UNITED STATES  
ATOMIC ENERGY COMMISSION  
WASHINGTON, D.C. 20545

Docket Nos. 50-269  
and 50-270

Change No. 9 License No. DPR-38  
Change No. 4 License No. DPR-47

OCONEE NUCLEAR STATION  
STATION ORGANIZATION CHART  
FIGURE 6.1-1

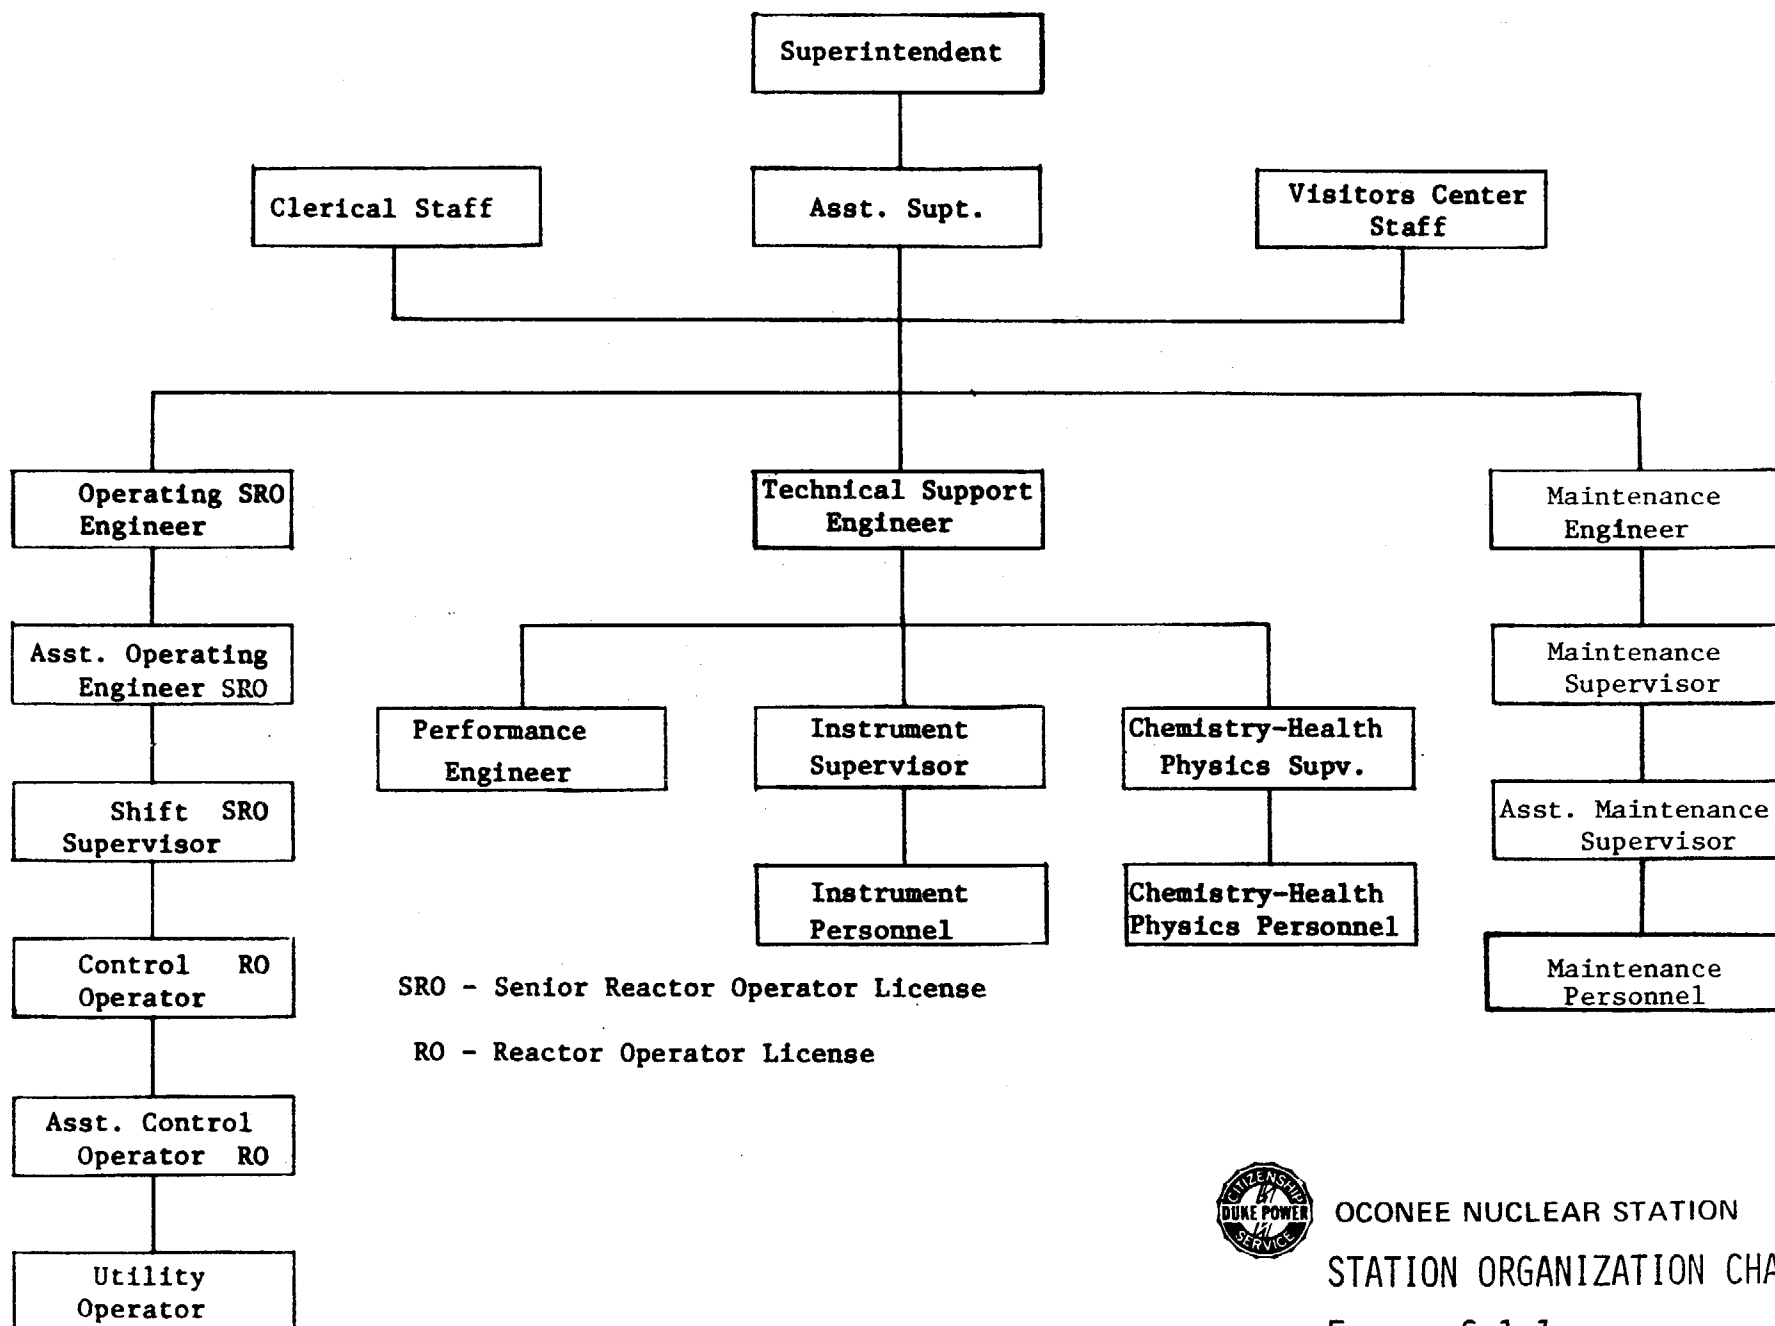
Your letter of December 19, 1973 requested that Technical Specification 6.1, Appendix A to License No. DPR-38 and No. DPR-47 be revised to include a Maintenance Engineer who will report to the Station Superintendent and to modify the membership of the Station Review Committee. We find that there is reasonable assurance that the health and safety of the public will not be endangered by this change.

Pursuant to Section 50.59 of 10 CFR Part 50, Technical Specifications, Appendix A to License Nos. DPR-38 and DPR-47, have been changed in accordance with the revised Technical Specifications 6.1 enclosed. These changes are identified as Change No. 9 to Technical Specifications License DPR-38 and Change No. 4 to Technical Specifications License DPR-47 and are effective on the date of issuance.
